## Product / Process Change Notification (PCN)

**PCN #:** PCN\_UtRJ45LAN\_20210728  
**Affected Series:** WE-UtRJ45LAN-Series; 7499xxx  
**PCN Date:** April 28, 2021  
**Effective Date:** July 28, 2021

### DESCRIPTION AND PURPOSE OF CHANGE:

1. Dimensions drawings from "max. values" to "tolerance values" with standardization of these dimensions

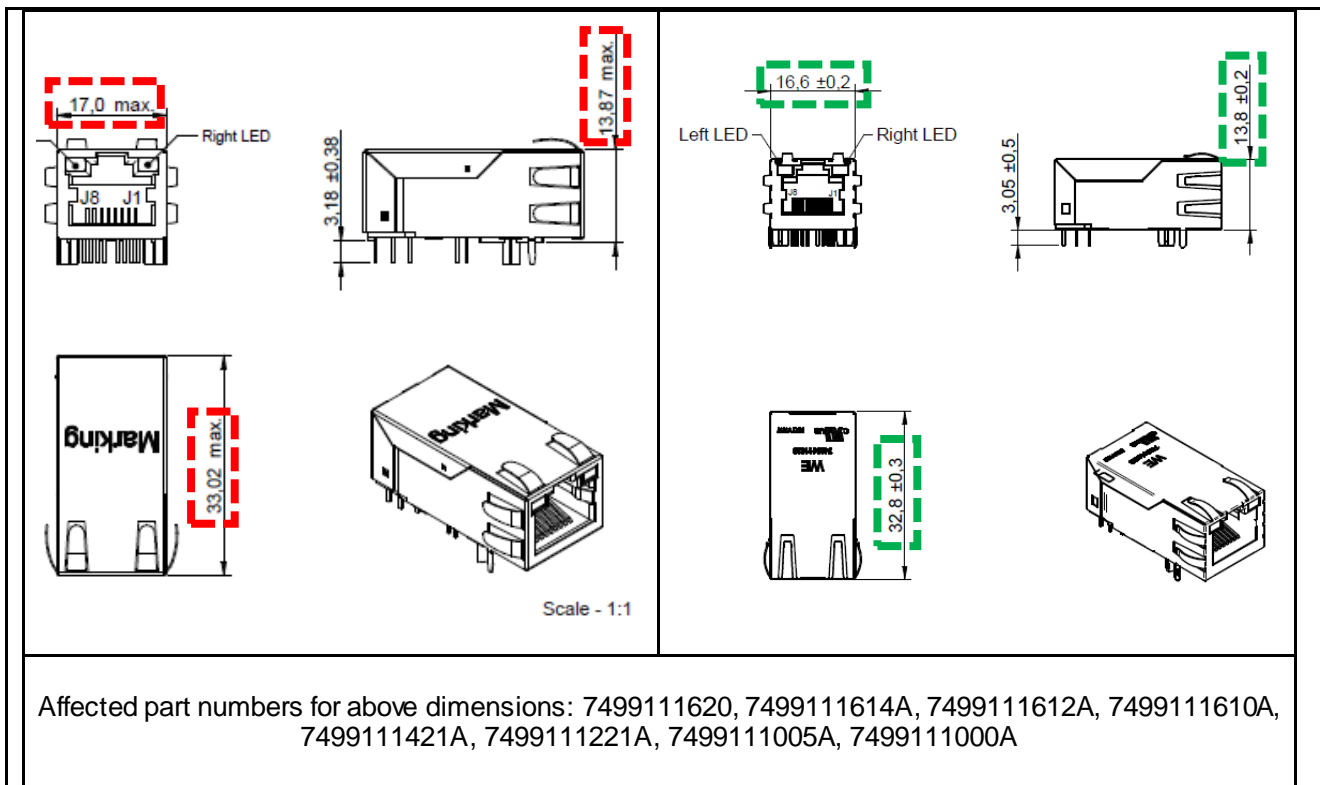
Before PCN	After PCN
<p>Scale - 1:1</p>

Affected part numbers for above dimensions: 7499511440, 7499511611A, 7499511002A, 7499511001A, 7499511420, 7499510002, 7499411123A, 7499411122A, 7499411121A, 7499211261
